**Strategic Planning for Future Power Generation
Pinjar Power Station Expansion
Kwinana/East Rockingham Power Station
Kemerton Power Station
New Bunbury Power Station
Collie Power Station Expansion**

Western Power Corporation

**Report and recommendations
of the Environmental Protection Authority
under section 16(e) of the Environmental Protection Act**

**Environmental Protection Authority
Perth, Western Australia
Bulletin 1067
September 2002**

Project No. WV02244.400
 Date Drawn: 08.08.2002
 Prepared by: T.Lee

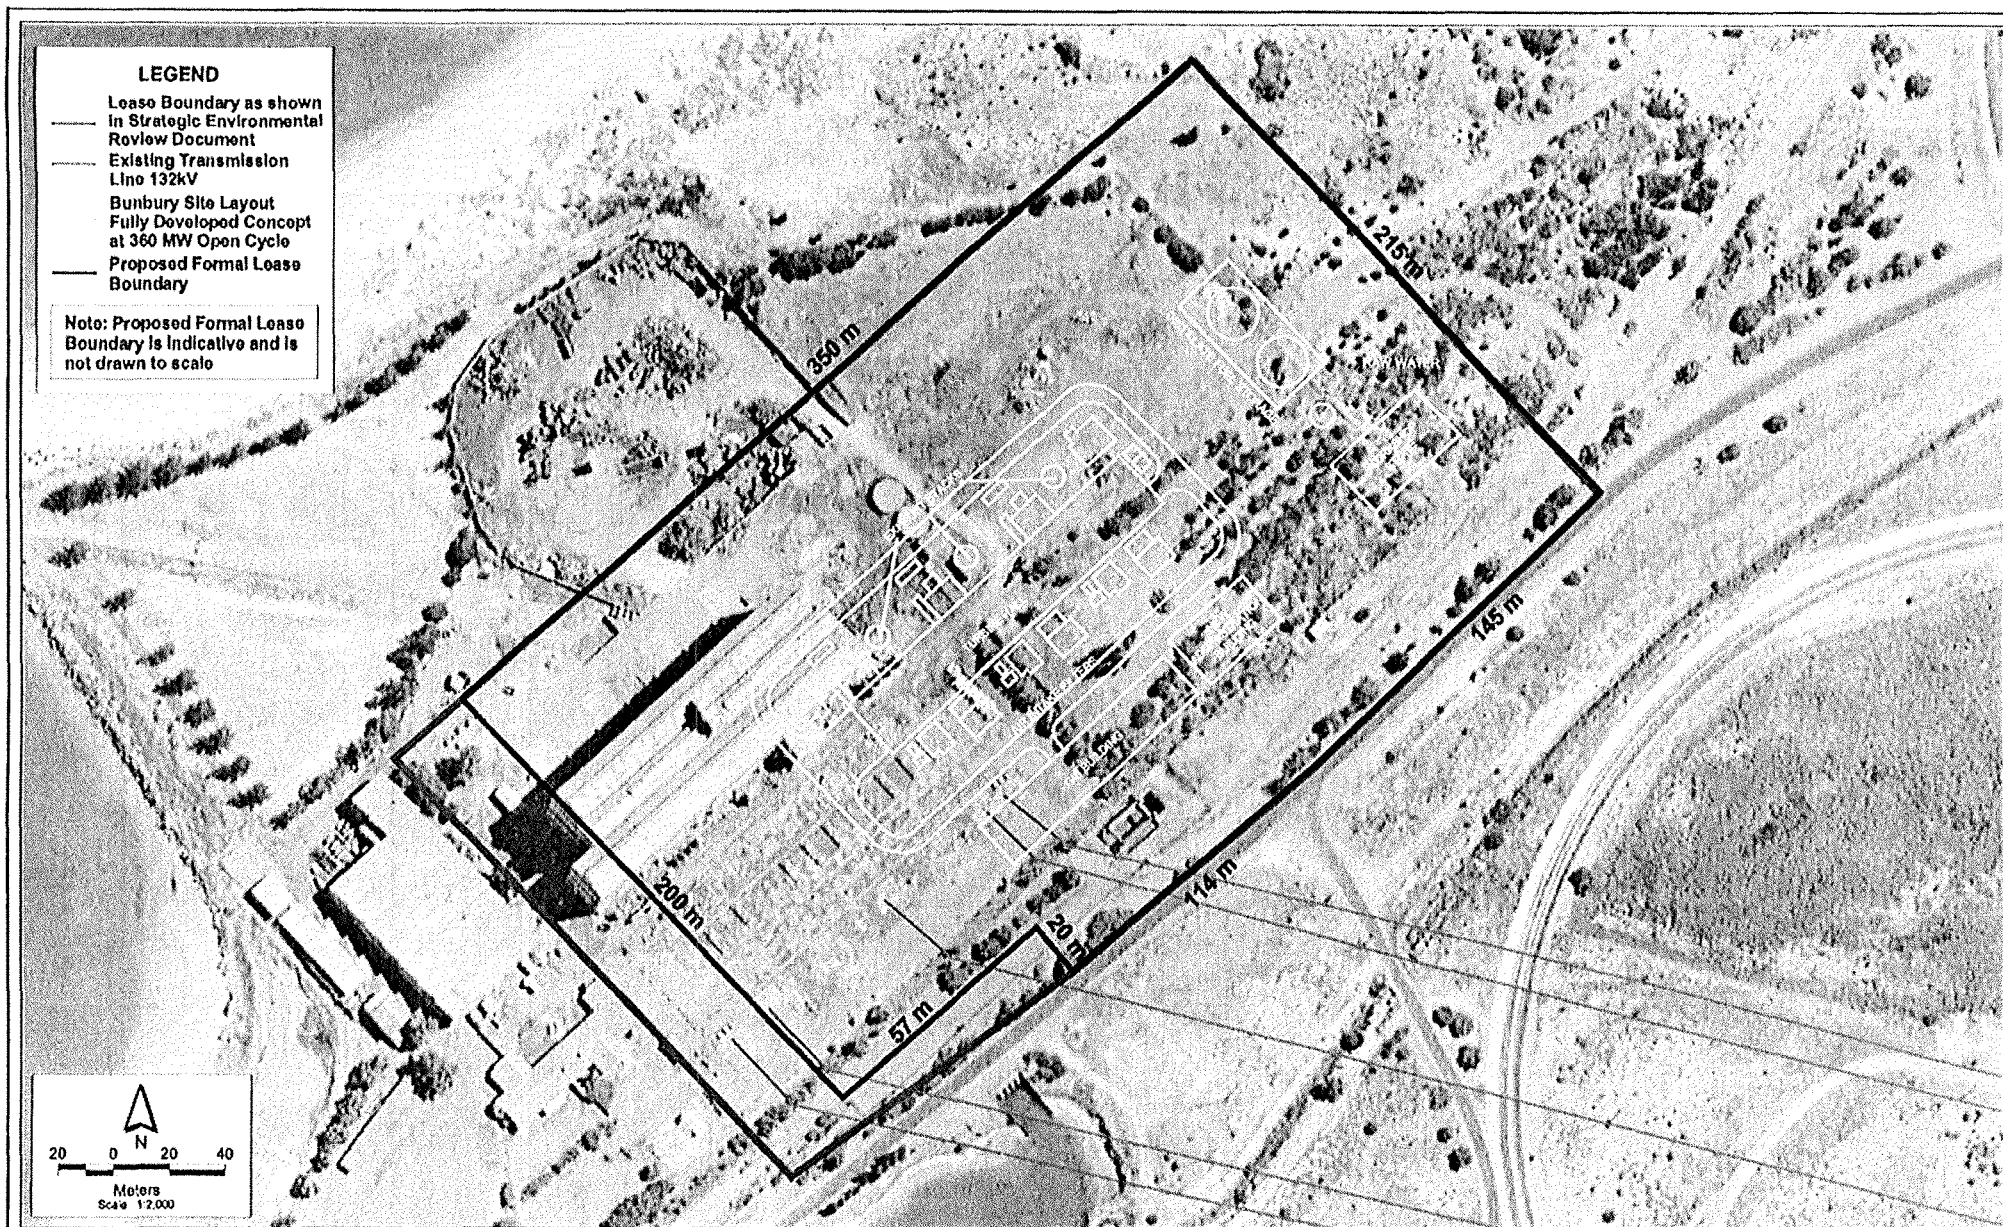
A submission pointed out that a portion of a conservation category wetland is within the site. In response to this the site layout and lease boundary have been modified to maintain a minimum of 200m separation to the nearest wetland.

The site layout for the preferred site at Kemerton has been further refined as a result of public submissions during the public review period. The new layout is shown in **Figure A-5 of Appendix A**. In this revised layout, the plant has been placed further to the north over the blue gum plantation to ensure that disturbance to the remnant vegetation in the southern portion of the preferred site is minimised. This revised layout also provides a distance of approximately 200m from the conservation category wetland in this portion of vegetation (refer to **Issue 33, Section 3.2.3.2**).

Figure 5-1 of the Kemerton SER presented a preliminary concept plan for the preferred site with indicative lease boundaries, which did include a portion of conservation category wetland in the southern most section of the site. However, in response to submissions through the public review process and ongoing liaison with LandCorp, the site layout and lease boundary have been modified. The revised power station layout (**Figure A-5**) would maintain a minimum of 200m separation to the nearest wetland such that disturbance to wetland vegetation is avoided.

The revised Kemerton power station development concept (**Figure A-5**) is separated from the conservation category wetland by a distance of approximately 200m and from the Environmental Protection Policy (EPP) wetland south of Treasure Road by a distance of approximately 300m.
